U.S. Department  
of Transportation  
**Federal Highway  
Administration**

# Road Safety Audit Center Street and Cooper Street Arlington, TX

DECEMBER 2024

*Figure 10: Driveway design resembling intersection at Cooper/Fuller*

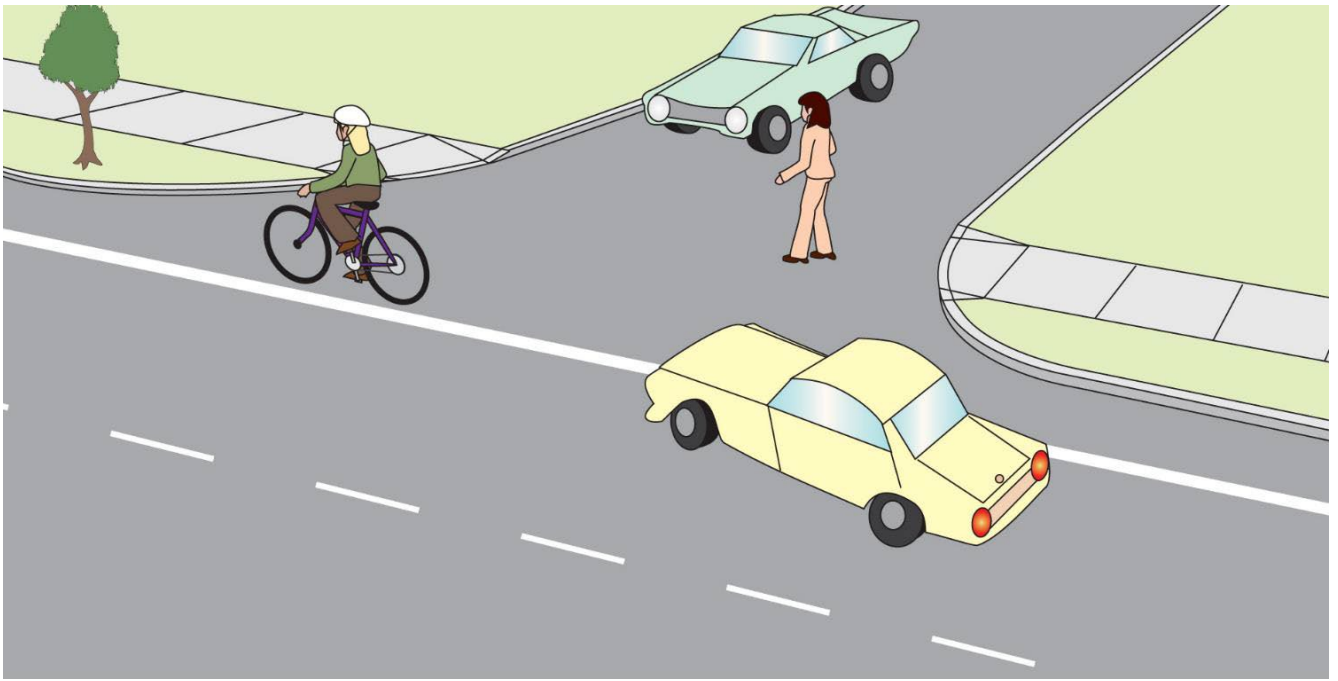
- Consider redesign of sidewalks across driveways to encourage driver yielding to pedestrians. Throughout the corridor, the sidewalks ramp down to street level at driveways. This creates a “rollercoaster effect” for pedestrians. The design prioritizes vehicle movement and allows for turns at high speeds, which decreases likelihood of drivers yielding to pedestrians. Timeline: Long-term.

Figure 15: Delineator hardened centerlines (source: [City of Minneapolis Street Design Guide](#))

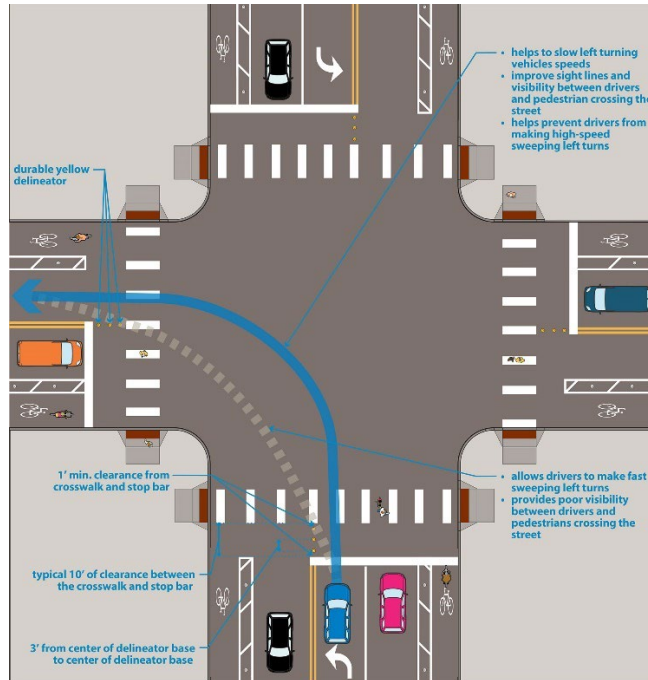
- **Observation:** There is no pedestrian refuge for the marked crosswalk on Cooper Street, and pedestrians have seven lanes to cross. The RSA Team observed most drivers failing to yield to pedestrians in the crosswalk. The RSA Team also observed that during school zone hours, the majority of drivers ignored crossing guards' instructions when making U-turns on the north side. **Recommendation:** The City could consider a wider median to provide a full refuge. In the interim, consider other countermeasures such as in-street pedestrian crossing sign (TxMUTCD R1-6) or centerline hardening such as the example in Figure 15. Timeline: Short-term for interim solutions, medium-term for pedestrian refuge.
